# ***RUSSELL VALE COLLIERY***

## ***REVISED UNDERGROUND EXPANSION PROJECT***

### ***Extraction Plan - Biodiversity Management Plan***

**RVC EC PLN 004**

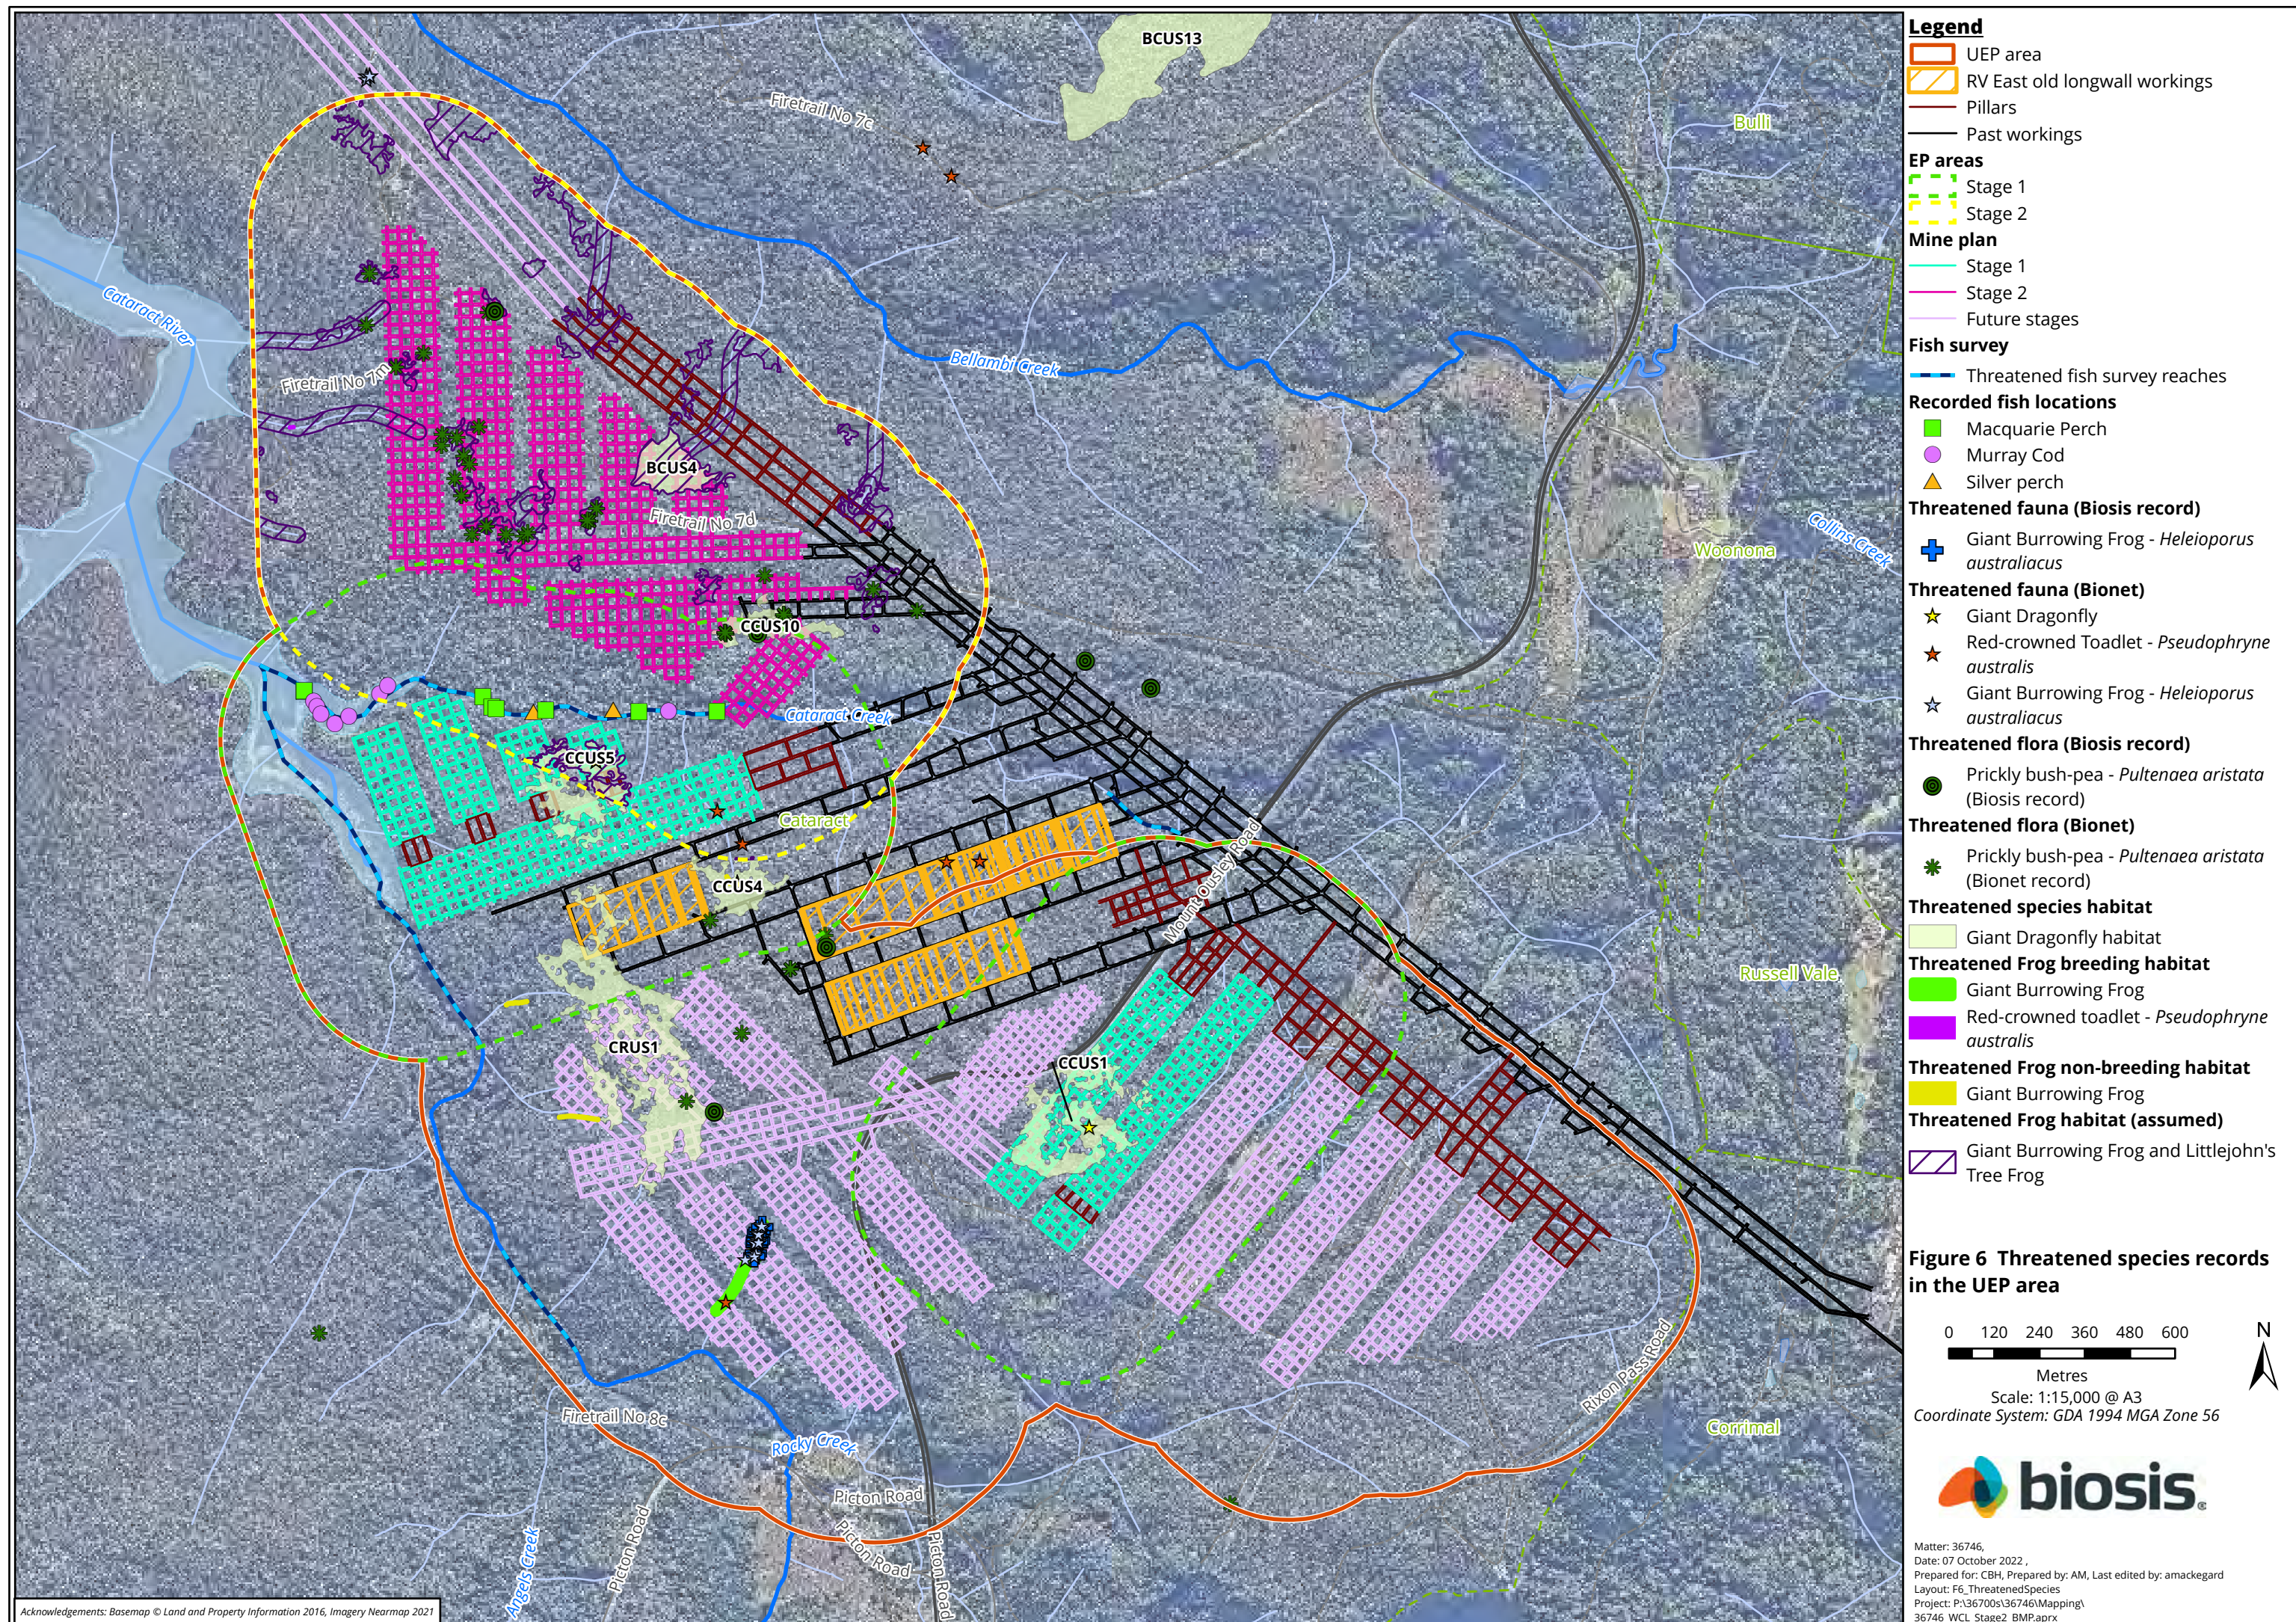
<p><b>Figure 6, Page 46</b> It is unclear why swamps in Stage 2 do not contain habitat for giant dragonfly? None of the swamps mapped in Stage 2 are mapped as habitat.</p>	<p>Suitability of swamps within the Stage 2 EP area will be confirmed during detailed field assessment as part of Stage 2 baseline monitoring, which is being currently undertaken. Any additional swamps identified as providing habitat for the Giant Dragonfly will be incorporated into the BMP.</p> <p>Note that there was an error in Figure 6 of the BMP, whereby the following impact swamps were not mapped as habitat but are considered to be Giant Dragonfly habitat: BCUS4, CCUS10. The map will be updated for the final BMP.</p>

Figure 16: Plan showing areas of existing and potential pillar instability in overlaying Bulli Seam.

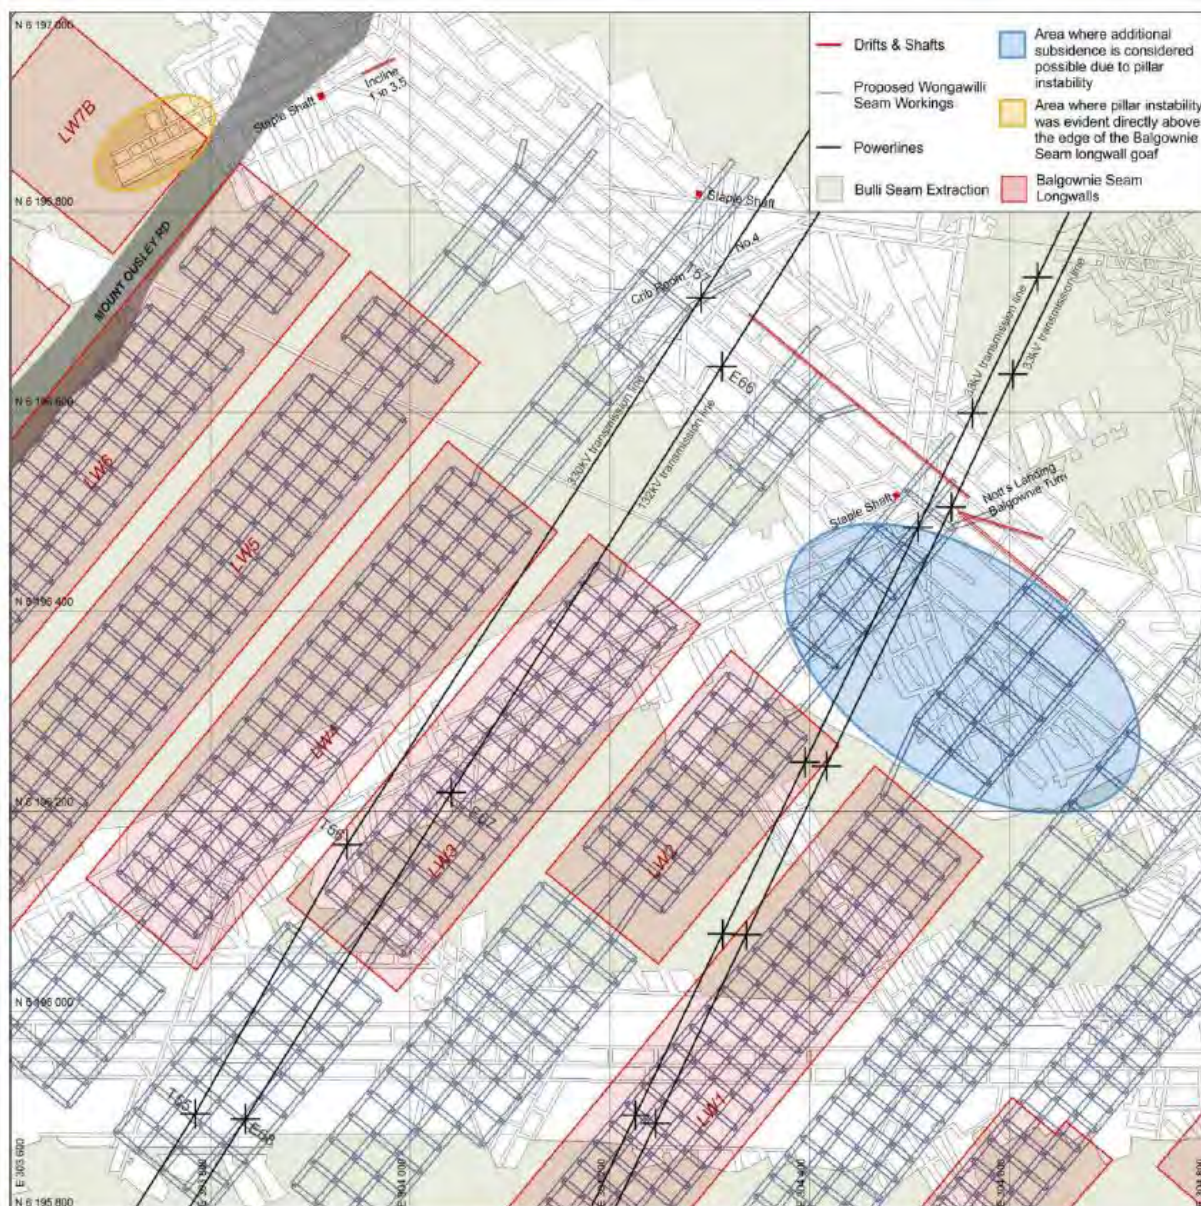
The phrase 'marginally stable pillars' and discussion around 'potential pillar instability' relates to consideration of irregularly shaped bord and pillar workings adjacent to the Bulli Seam main headings. These are shown in Figure 16 of the SCT Subsidence Assessment (reproduced below in **Figure 2.1**). The SCT Subsidence Assessment includes the following commentary regarding these 'marginally stable pillars':

It is therefore important to recognise that the consequences of subsidence associated with the failure of these marginally stable pillars is almost certain to occur at some time in the future irrespective of whether or not the Project proceeds. The Project therefore does not cause the subsidence impacts that will arise from the eventual failure of these pillars (this is the result of historical mining which occurred prior to 1950), however the potential for the Project triggering the failure of these pillars cannot be ruled out.

None of the marginally stable pillars are located below swamps nor is the failure of these pillars likely to impacts on any creeks, cliff lines or rockshelf features. As such, the environmental impacts of a failure of these pillars is likely to be negligible. These pillars are however located in close proximity to high voltage transmission line towers (refer to **Figure 2.1**) and the detailed mine design will need to have regard to the management of these features. This is discussed further in **Section 3.0**.

Figure 2.3 Goaf Areas Considered in SCT Subsidence Risk Assessment

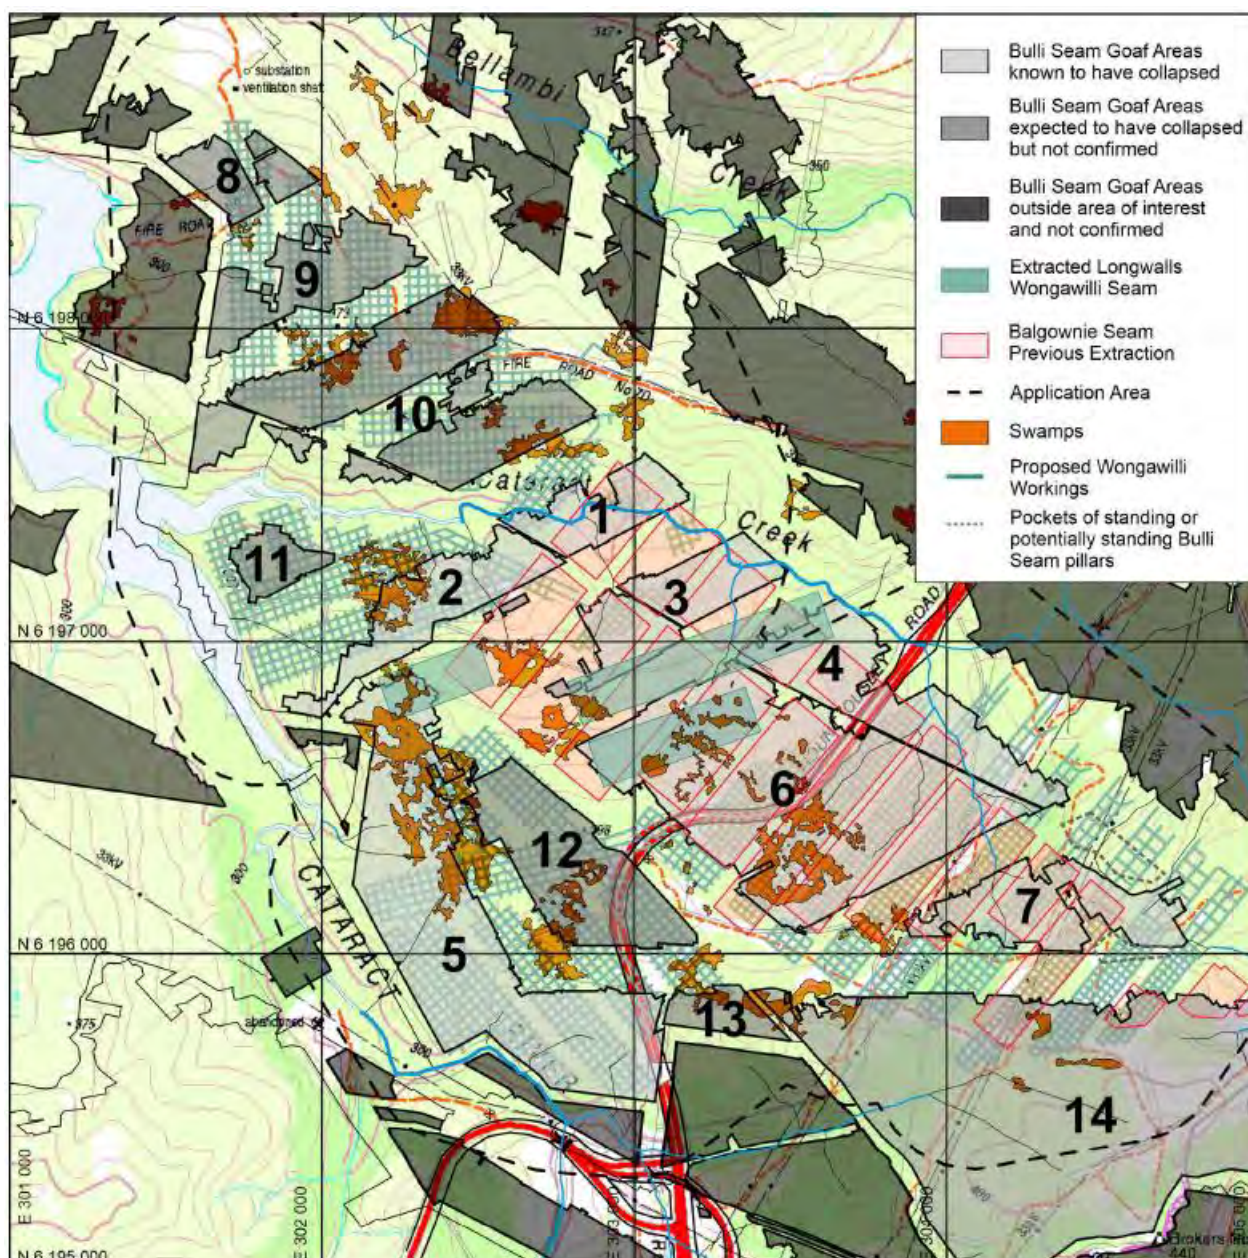
These grey/black shaded areas correspond to the 14 ‘Bulli Seam goaf areas’ considered in the SCT Subsidence Risk Assessment (SCT, 2020: refer to Figure 1 in the SCT Subsidence Risk Assessment – reproduced in **Figure 2.3**). Section 2.3.2 of the SCT Subsidence Risk Assessment (SCT, 2020a) describes these areas as follows:

**Figure 2.4 Upland Swamps Considered by IAPUM**

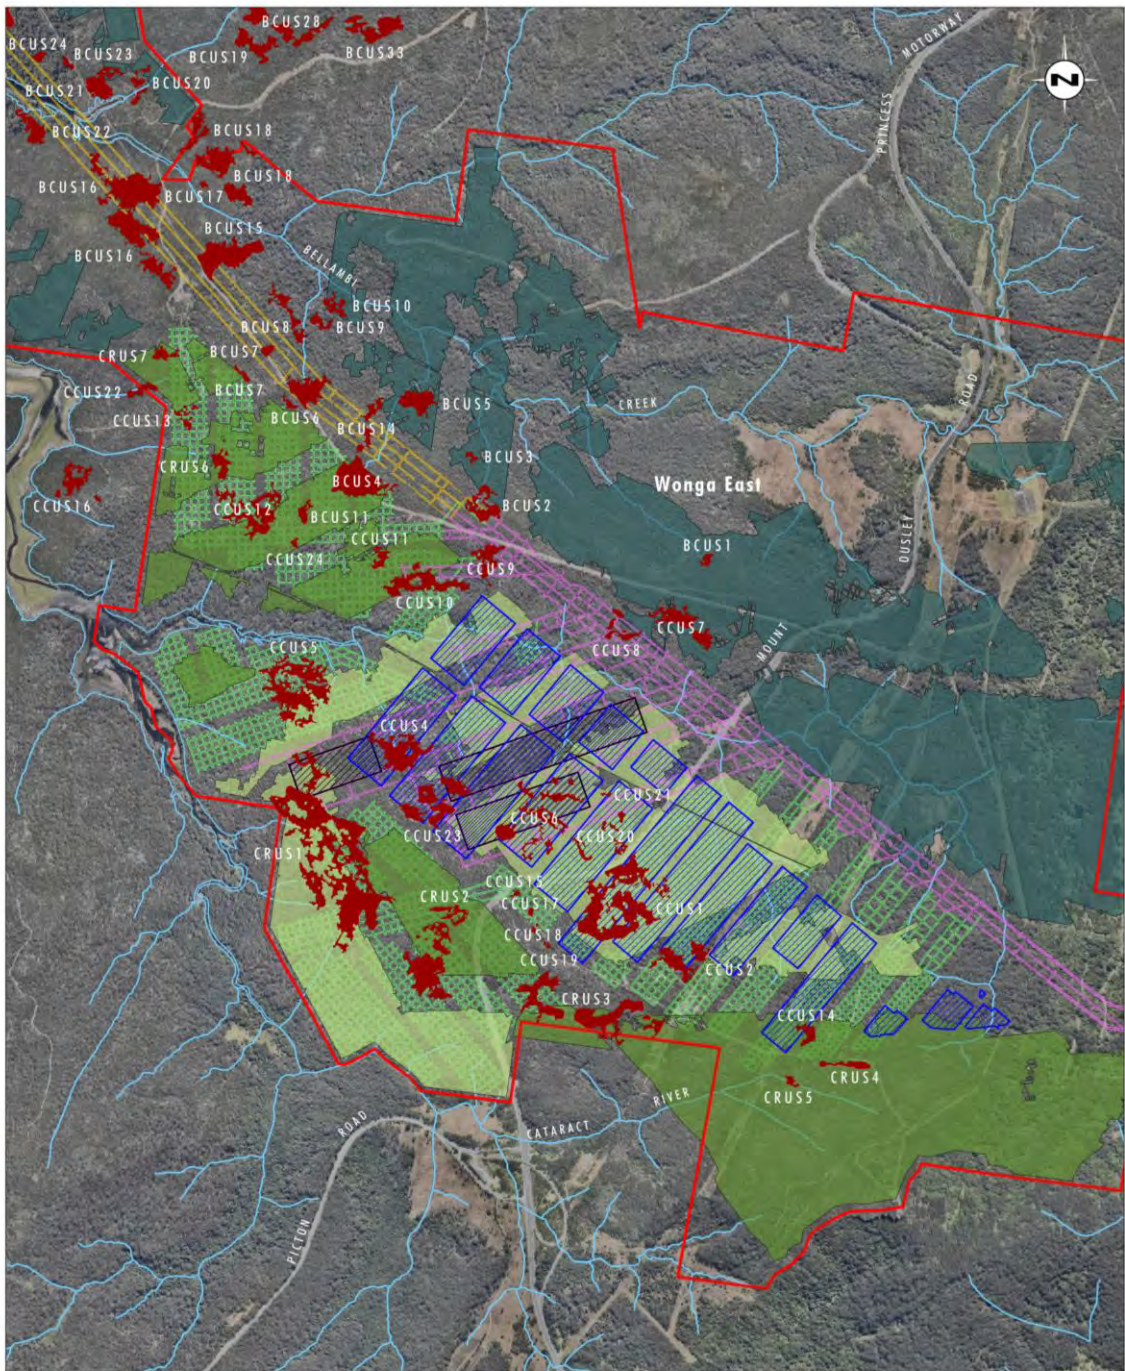
The four upland swamps identified in the IAPUM Advice as already having experienced tensile strain impacts of over 10 mm/m (CCUS1, CCUS6, CCUS20 and CCUS21) are all located over Area 6 (refer to **Figure 2.4** and **Table E.1.1** in **Appendix E**). Area 6 is one of the Bulli Seam goaf areas confirmed as having been fully collapsed. Of these four swamps, neither CCUS6 and CCUS21 will be directly undermined by the proposed first workings in the Wongawilli Seam and are unlikely to experience any additional subsidence effects from the proposed mining.

Figure 1: Concept of GNSS monitoring points relative to existing goaf areas and swamp locations.

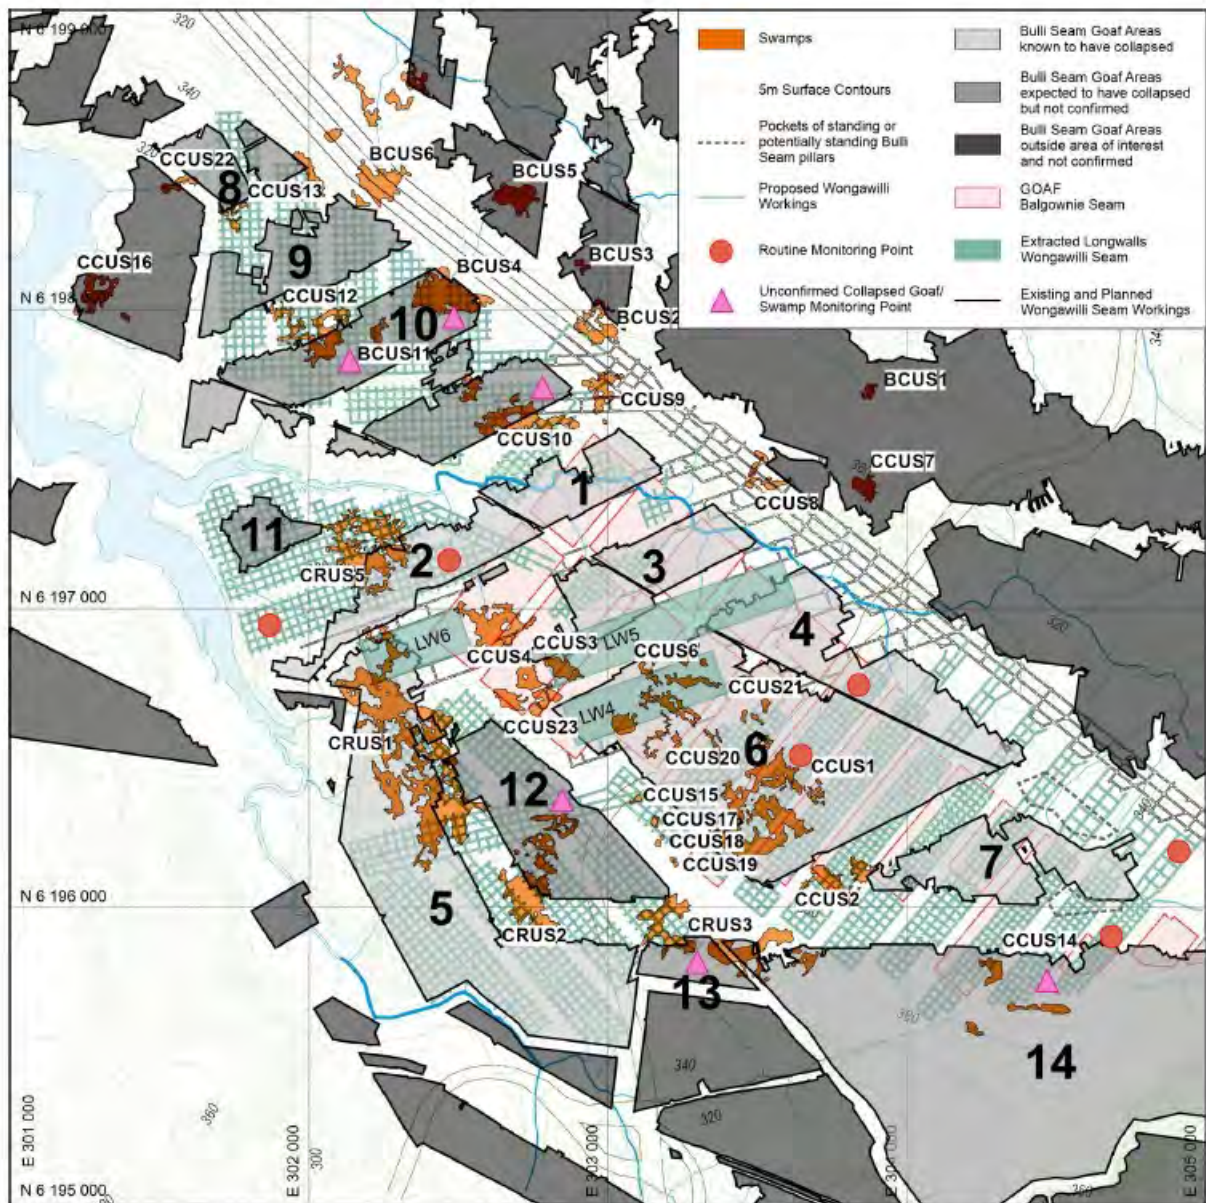
Figure 1 shows the concept of the GNSS units installed for routine monitoring of three continuous miners (CM) forming first workings in the Wongawilli Seam and the Bulli Seam goaf areas yet to be confirmed as collapsed where swamps are located above the proposed workings. The configuration shown assumes one CM unit is operating west of Longwall 6, one CM unit is mining east of Longwall 4 and one CM unit is mining at the eastern edge of the proposed mine plan area. It is recognised that three of the seven goaf areas (#8, 9 and 11) not confirmed as collapsed do not have any substantial areas of swamps above them and would not necessarily be monitored with a GNSS unit but would still be covered by the proposed InSAR technique.

As shown in Figure 1, it is intended to monitor subsidence movements above areas where it is possible there may be:
